**ALBERTA TRANSPORTATION SPRINGBANK OFF-STREAM RESERVOIR PROJECT
RESPONSE TO NRCB AND AEP SUPPLEMENTAL INFORMATION REQUEST 1, JULY 28, 2018**

**APPENDIX IR14-5 DAM ALIGNMENT AND TOE LOCATION
RELATIVE TO THE ELBOW RIVER OF THE
SPRINGBANK OFF STREAM RESERVOIR
PROJECT**

Reference: Dam Alignment and Toe Location Relative to the Elbow River

DAM ALIGNMENT AND TOE LOCATION
 RELATIVE TO THE ELBOW RIVER
 ATTACHMENT 1
 STORAGE DAM LOCATION -
 CONCEPT COMPARISON

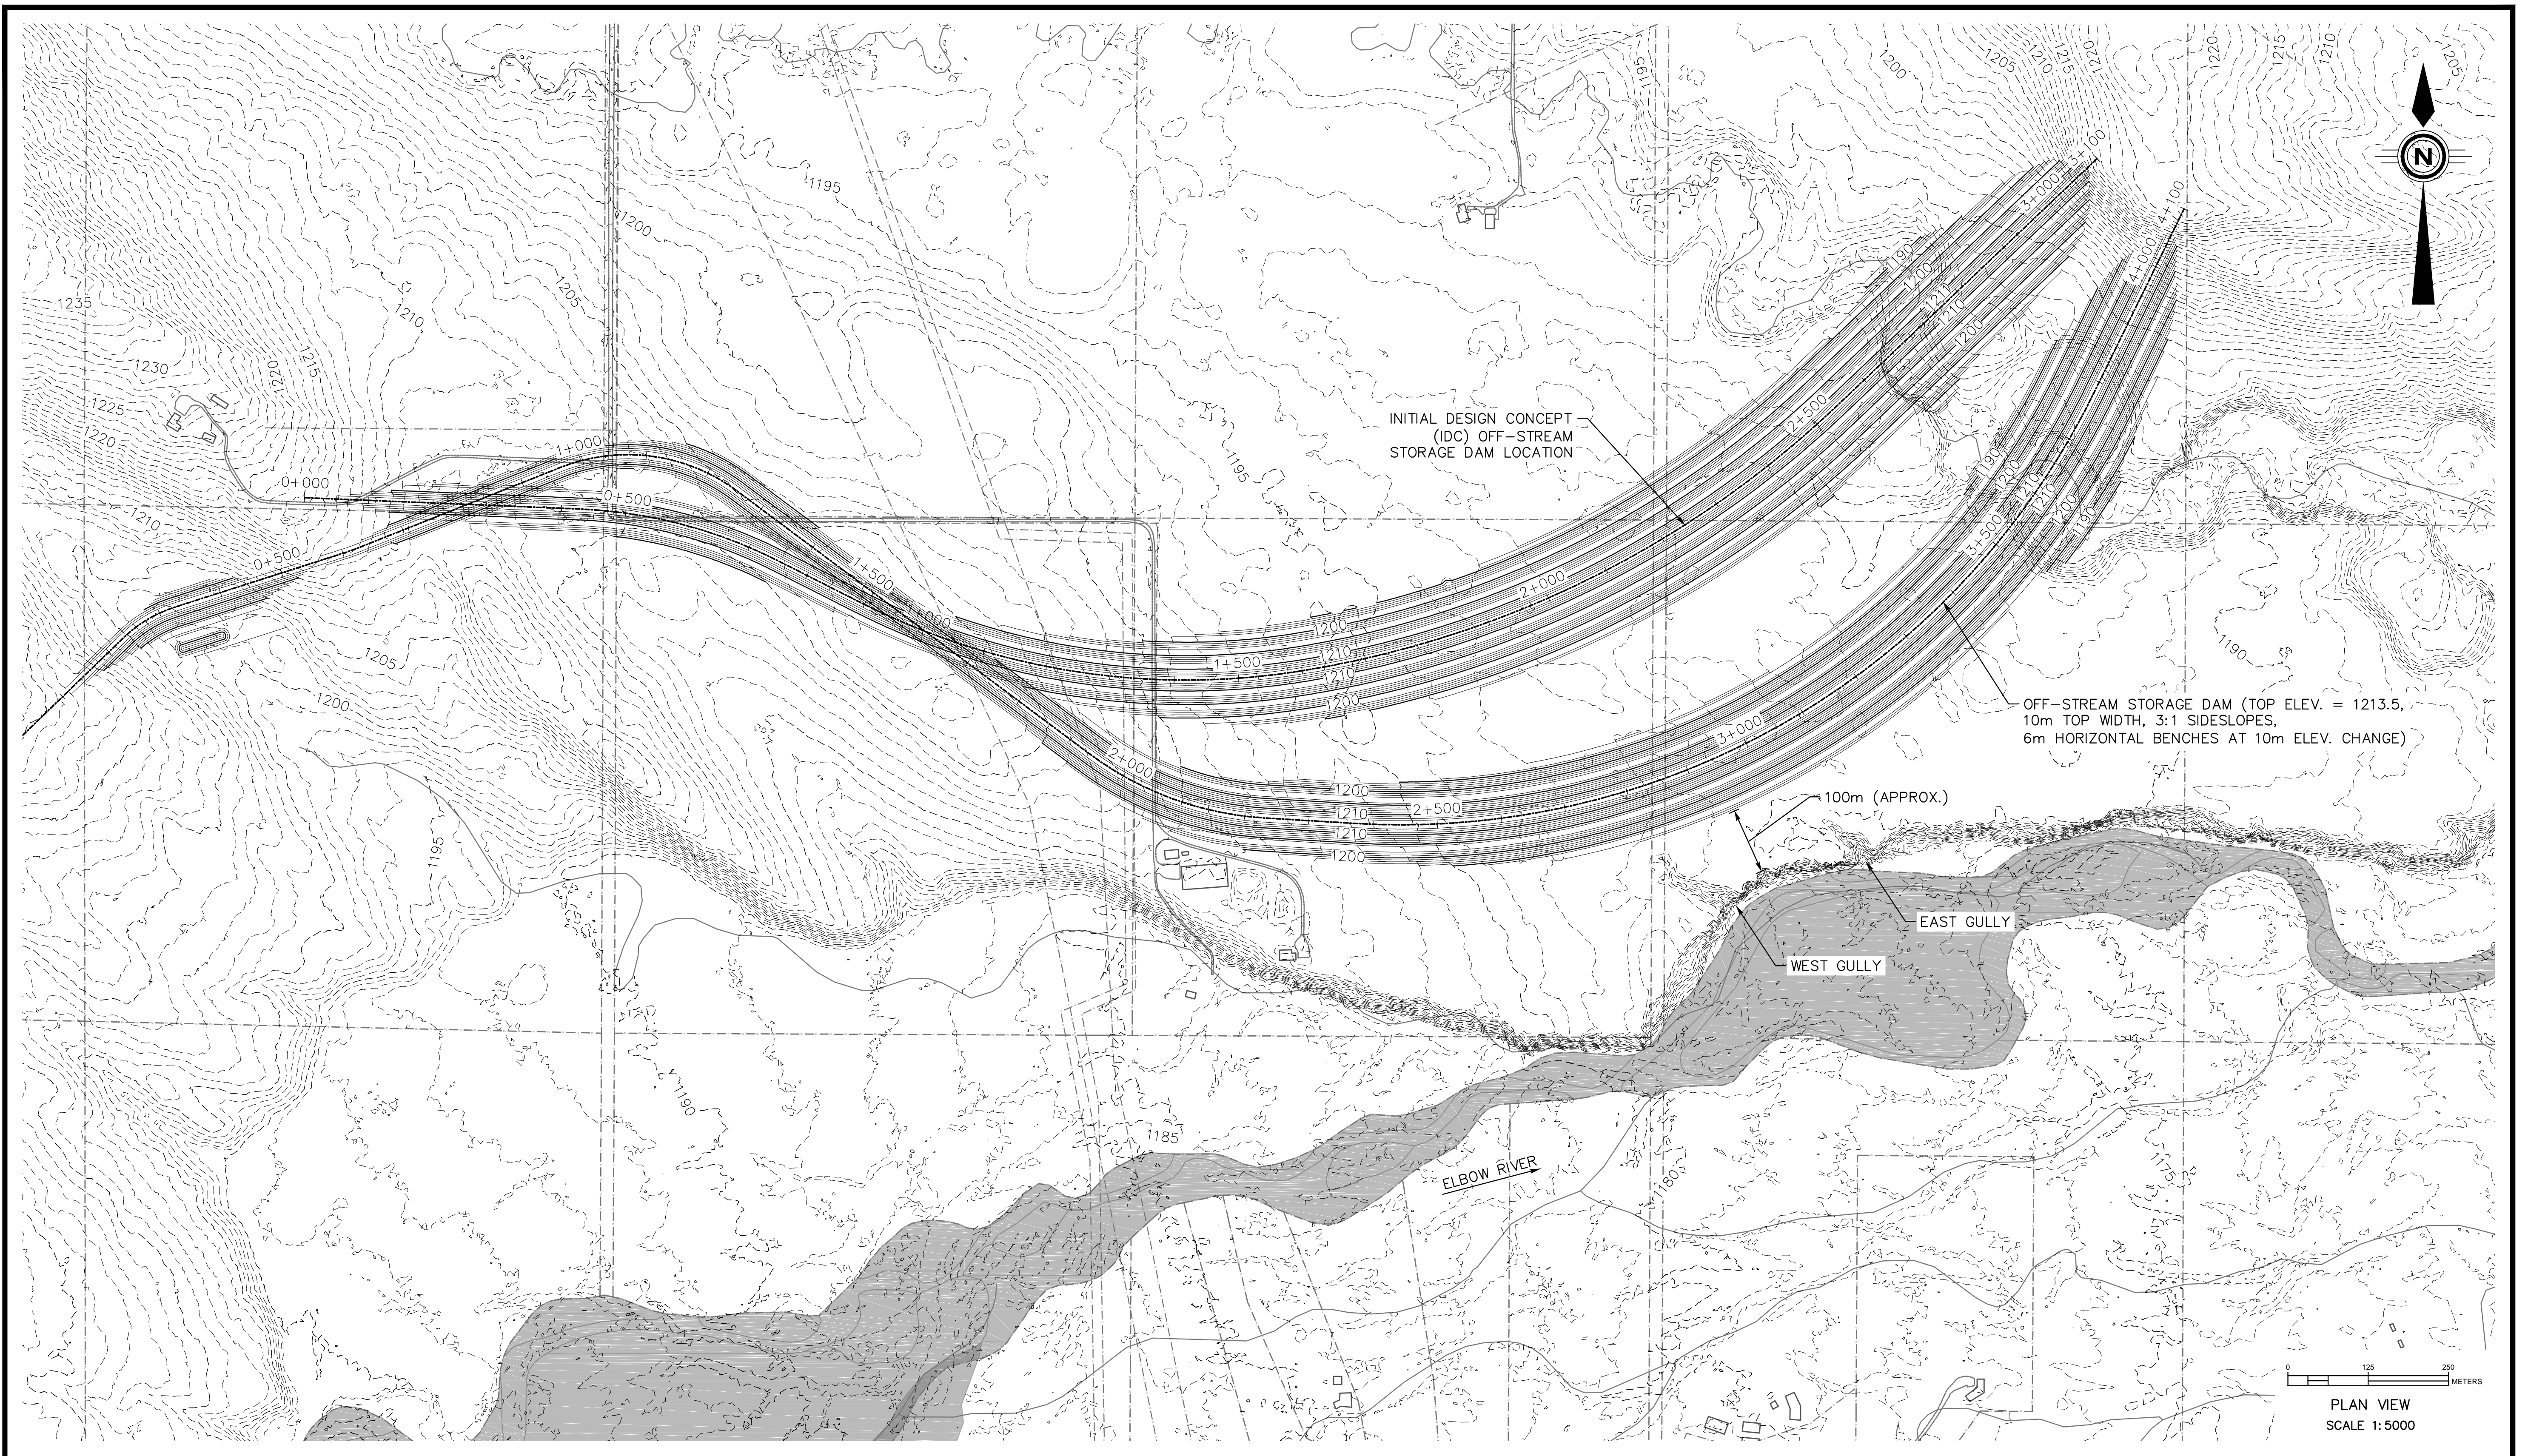
- 3. RB:** *The Board recommends that the benefits, design implications, and costs of moving the SR1 Dam further downstream, resulting in a possible lowering of the reservoir storage levels or, alternatively, providing additional storage, be further investigated, with due regard to the safety of the SR1 Dam toe under extreme flood conditions in the Elbow River.*

A comparison of the IDC (June 2014) and Stantec conceptual design (May 2015) storage dam alignment is shown in Attachment 1.

Stantec performed site reconnaissance along the toe of the Elbow River banks near the dam toe area on May 3, 2016. Two gullies were observed near the location where the dam toe is closest to the top of the Elbow River bank. The two gullies are shown in Attachment 1 in plan view. Photographs of the gullies are shown below in Figure 1; the photographs give good perspective on the size and scale of the gullies. The gullies were not reviewed in detail due to land access constraints.

Stantec recommends moving the Dam up-valley 100 metres from the preliminary design concept location presented in April 2015. The impacts of this change are negligible for cost (fill quantity and emergency spillway) and footprint area.
